Application PL/2023/033359

Construction and operation of anaerobic digestion facility, ancillary infrastructure, and construction of new access from Ashton Road, SN6 6QT

Applicant's Response to Wiltshire Council's Landscape Officer consultation response dated 18.04.2024

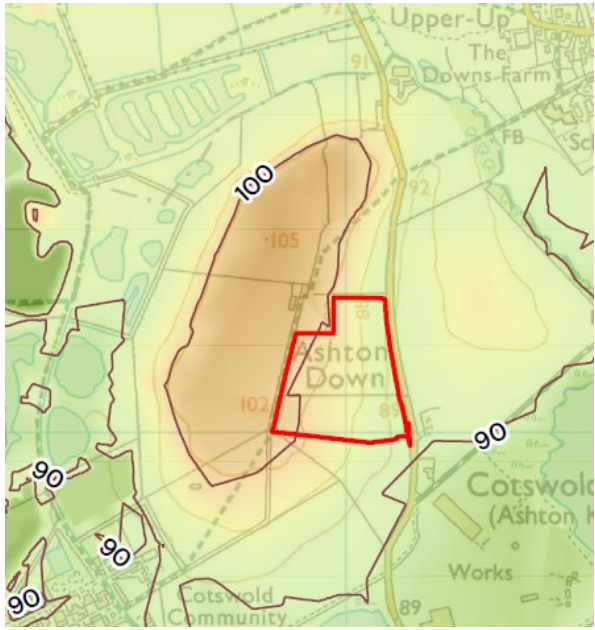
Landscape Character	
The LO quotes the published landscape character assessments at a national, district and local level. It is then stated that <i>'the site and its local context are consistent with the descriptions contained within the hierarchy of published landscape character assessments.'</i>	The published documents and landscape types quoted by the LO are consistent with Table 7.2 of the LVIA. It is disagreed, however that the Site and local context (of the Site) are fully consistent with the published descriptions that are

Landscape Officer comment	Pegasus Response
	reproduced at paragraphs 7.3.11 to 7.3.32 of the LVIA. At paragraph 7.3.3 of the LVIA it is stated: <i>The following paragraphs analyse the Site's landscape character, based on an on-site assessment, and verify it against the published reports, mentioned in the previous paragraphs. By doing so, this LVIA aims to identify the landscape value and landscape susceptibility to Anaerobic Digestion Facilities. The analysis is carried out in accordance with Box 5.1 of the GLVIA3...</i> The LVIA concludes at 7.3.39-7.3.40 that: <i>The Site and adjacent fields do not appear to contain any landscape features that would be rare or unique, however, some of the adjacent fields border Cotswold Water Park SSSIs to the east and west, and a Scheduled Monument to the southwest. There is no formal public access to the Site, however a PROW Footpath runs parallel to the western extents of the Site. Based on the above analysis, the value of the Site and local landscape is assessed as being medium.</i> In terms of landscape susceptibility it is stated at paragraph 7.3.42: <i>The contrast to the modern agricultural landscape is the presence of significant industrial activity including mineral processing to the southeast of the Site at Aggregate Industries, extraction and progressive restoration at Shorncote Quarry ca.500m to the west, the Cirencester Wastewater Treatment Works ca.950m to the northwest, and Evergreen Industrial Park within South Cerney ca.530m to the east. These industries contain major infrastructure and are locally detracting features in the landscape with indirect effects upon landscape character resulting in HGV traffic along Ashton Road, adjacent to the Site. The existing vegetation within the study area filters views of these urbanising land uses in a flat landscape, indicating that large scale industrial and mineral extraction operations can be accommodated with only localised adverse effects.</i>
